SERVICE LETTER NUMBER 132			
TITLE: LARGE WATER RUDDER INSTALLATION			
BY: E. BISHOP	AIRCRAFT MAKE/MODEL(S):	FLOAT MODEL(S):	NOTE(S):
APP: D. GARRETT	de Havilland DHC-2 Mk I and	6000	OPTIONAL COMPLIANCE
DATE: 22-JUN-12	Mk III Beaver; Pilatus PC-6 /	6100	S/L P/N 1005806
REV: A	B2-H4 Porter		ECO--22855

SERVICE LETTER P/N: 1005806

Figure 1. Installation of new 8000 water rudder.

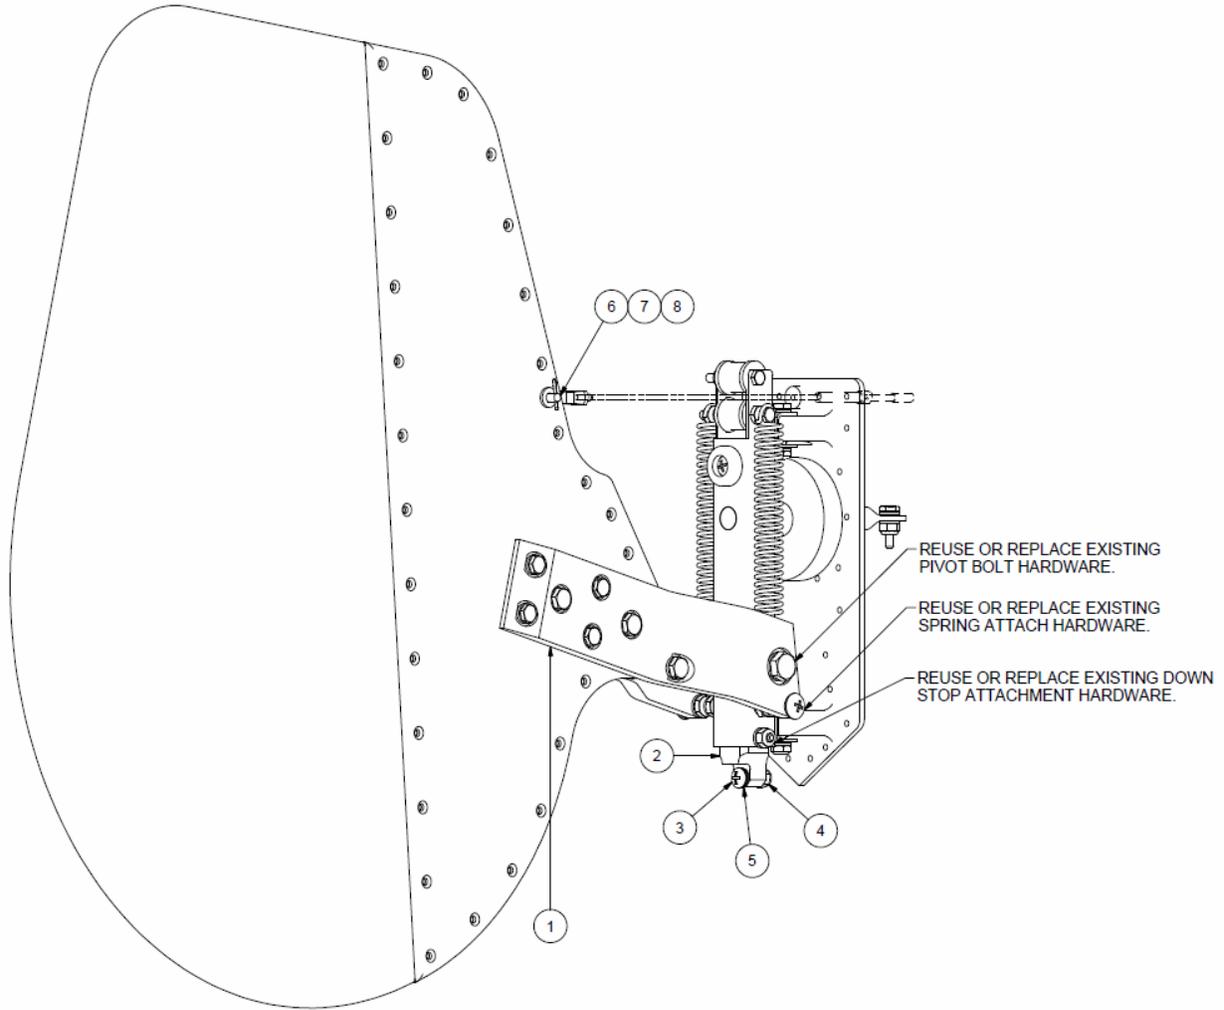
Install the new 1004372 down stop on the bottom of the water rudder post and secure with existing hardware. Attach arms to water rudder pivot and secure with existing hardware. Reinstall springs and secure with existing hardware. See Figure 1.

Check rigging of retraction system. Retraction cable will likely need to be lengthened so that when in the down position, the water rudder contacts the down stop with the cable just slack. Adjust cable length as needed. The down stop is also adjustable depending on the desired water rudder steering stability. It is recommended to start with the most stable configuration (screw plus three NAS1149C0332R washers) and remove washers only if steering is desired to be less stable. The screw may also be removed for less stability. Note that the washers may be substituted with NAS1149C0316R or NAS1149C0363R washers as long as the overall thickness is .096 inches, or less as desired.
